**DEVIATION REQUEST
AND DECISION FORM IN
ASSOCIATION WITH
A REQUEST FOR A PUD
MODIFICATION FROM
THE ECM**

Project Name : MEADOWBROOK PARK

PROPOSED MEADOWBROOK PARK PUD PRIVATE ROAD CROSS SECTIONS

RE: Meadowbrook Single Family Home Project
Residential Properties Zoning RR-5, CAD-O

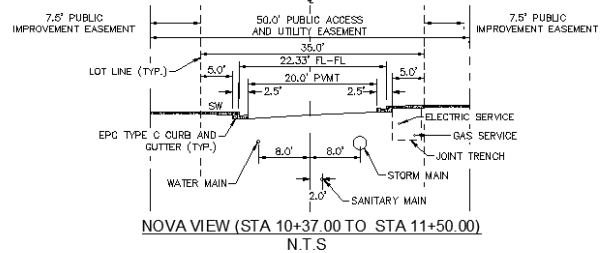
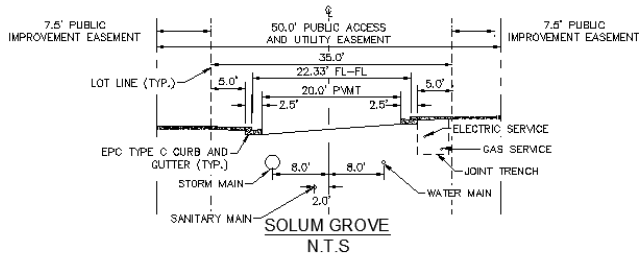
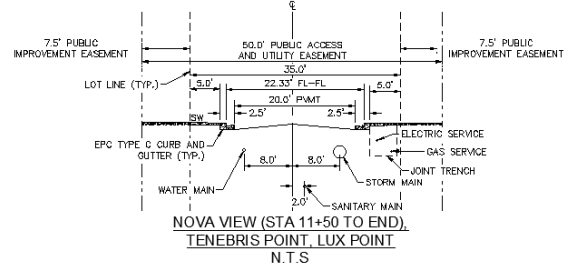
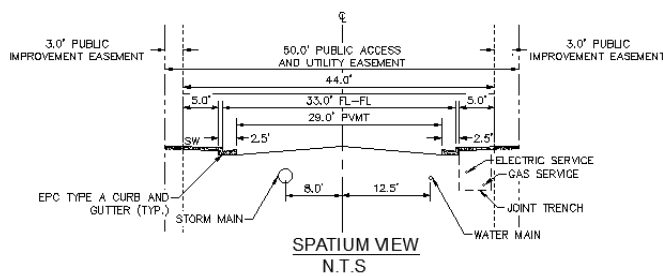
please include centerline radius as the recently included radius data provided does not meet ECM criteria.

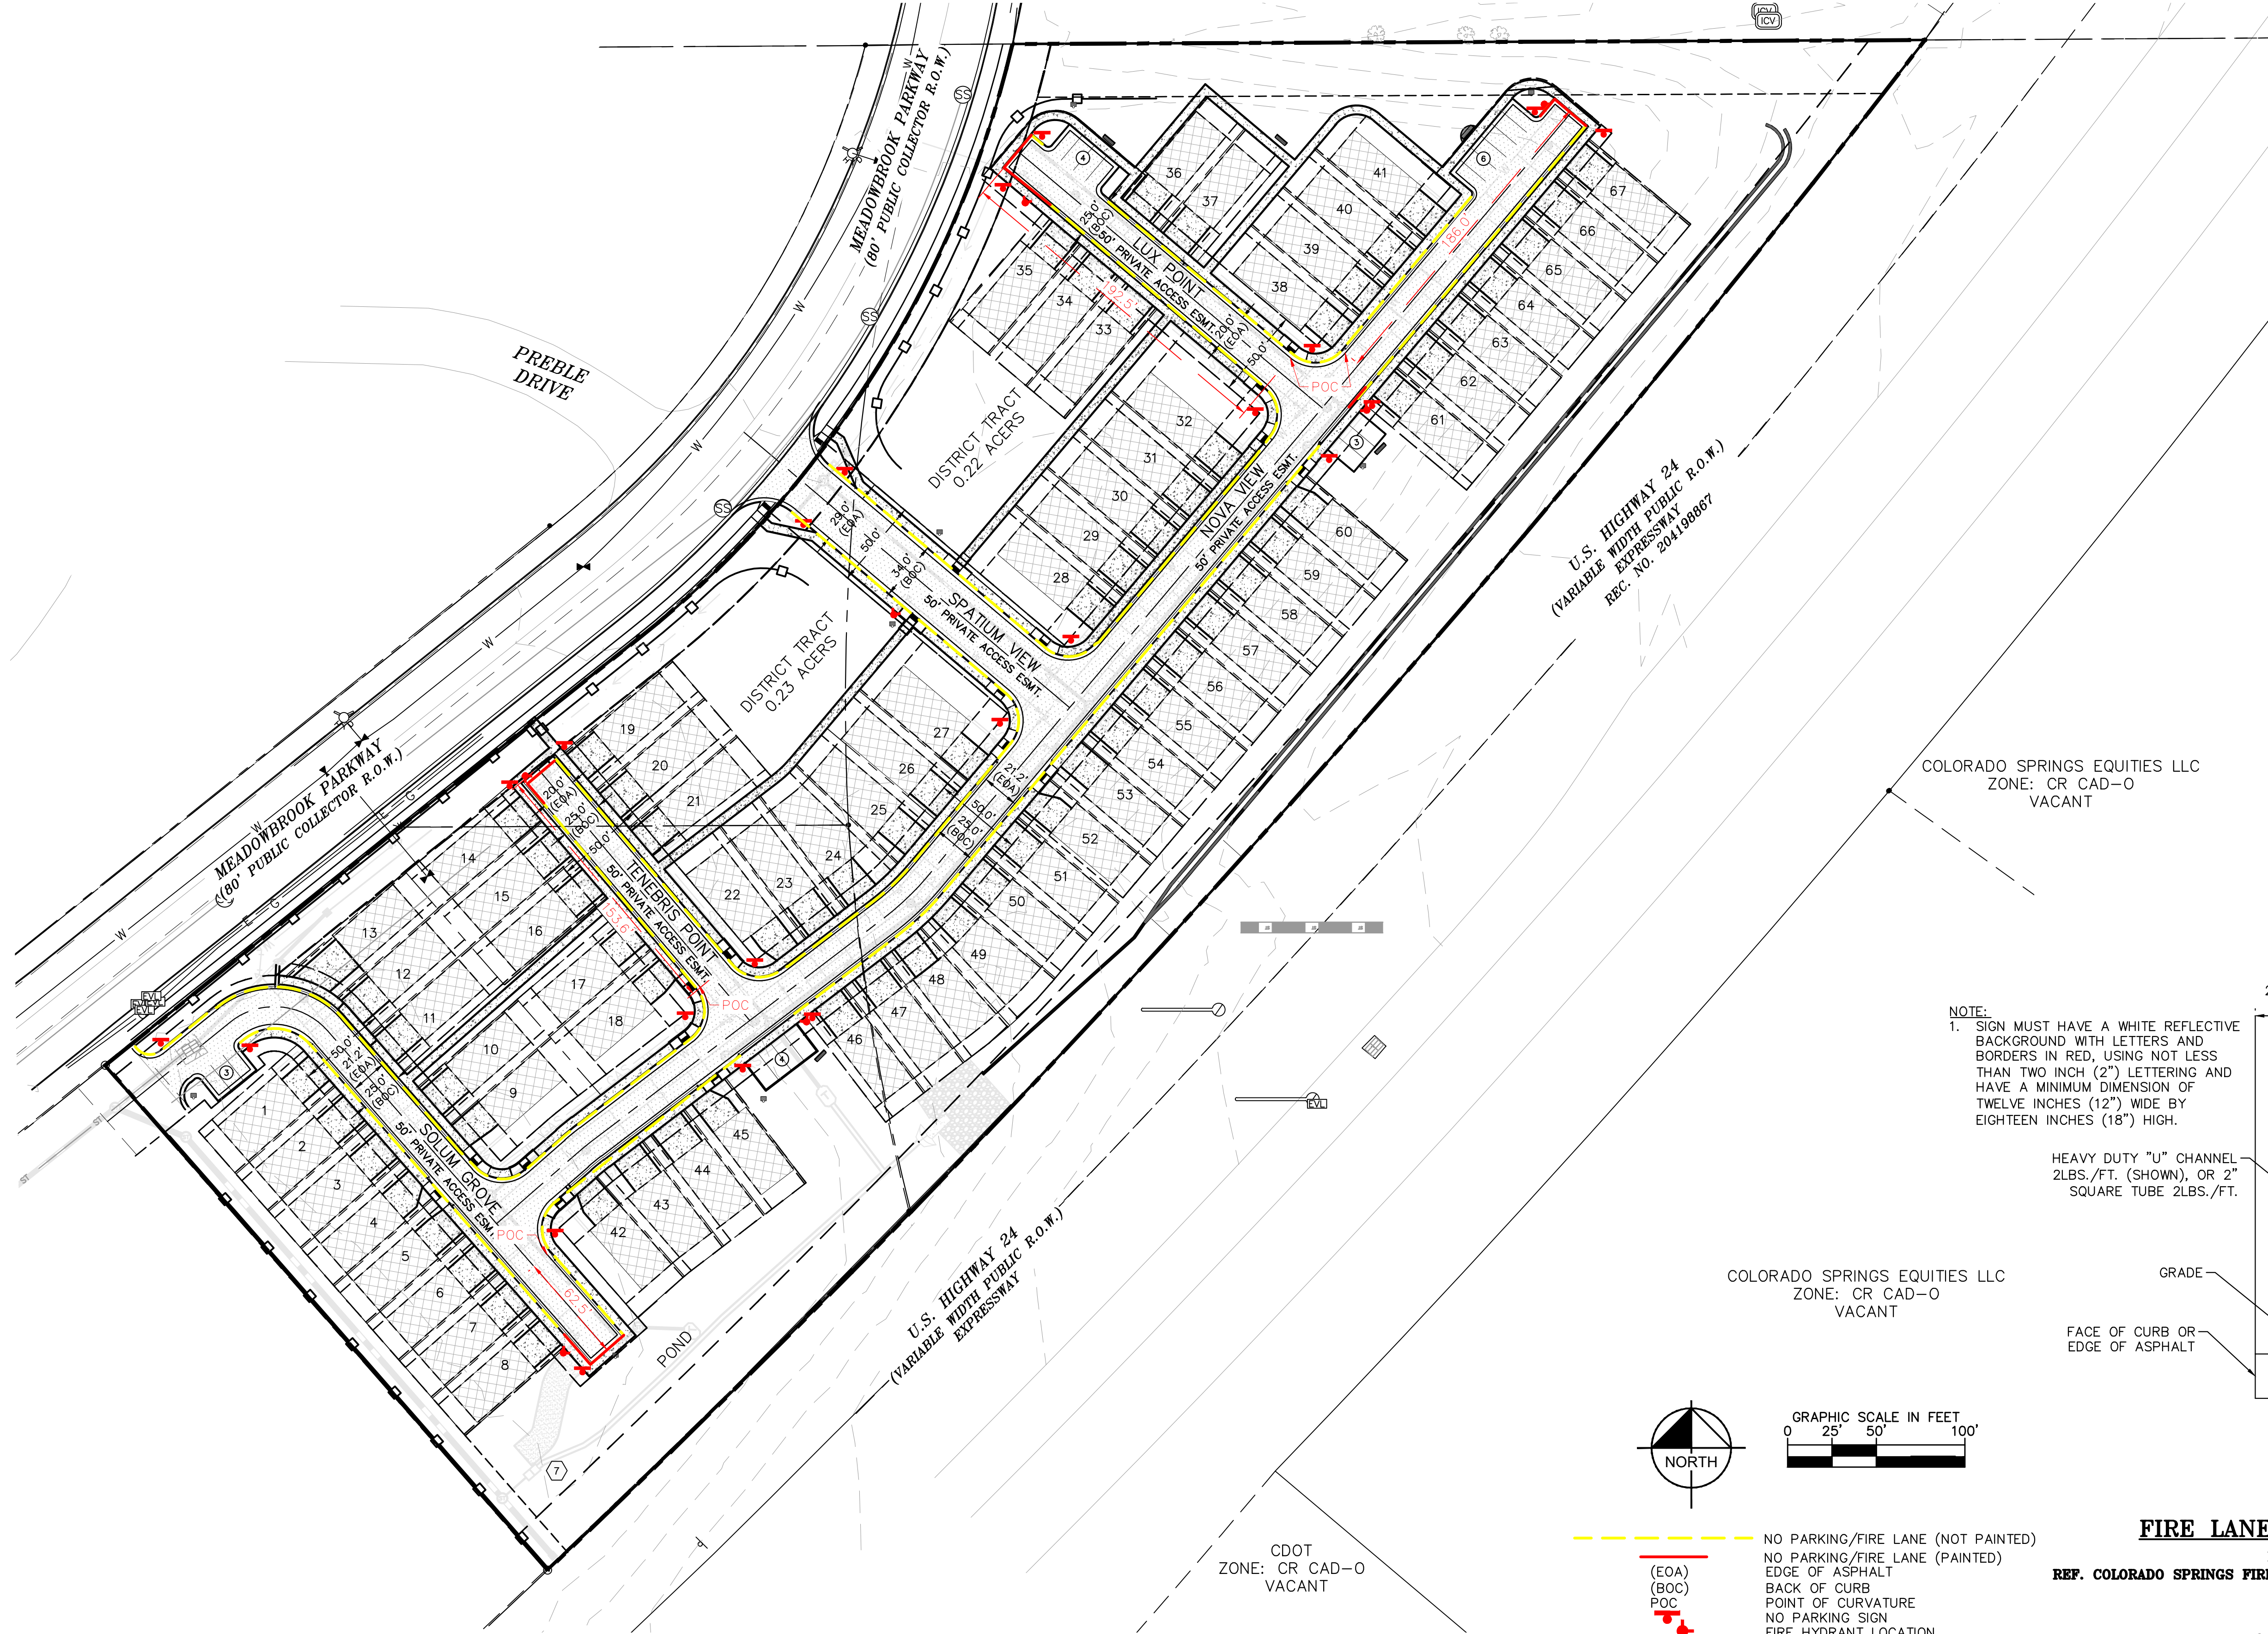
- ✓ The shown road widths are acceptable and fire lanes that will be provided will give us the access that we need. Turning radius and access are within our apparatus specs.
- ✓ Dead end lengths are acceptable per our CHFD Amendments as fire hydrants will be added to give us adequate flows and connections.
- ✓ KNOX box gate access is allowed for emergency access and approved.
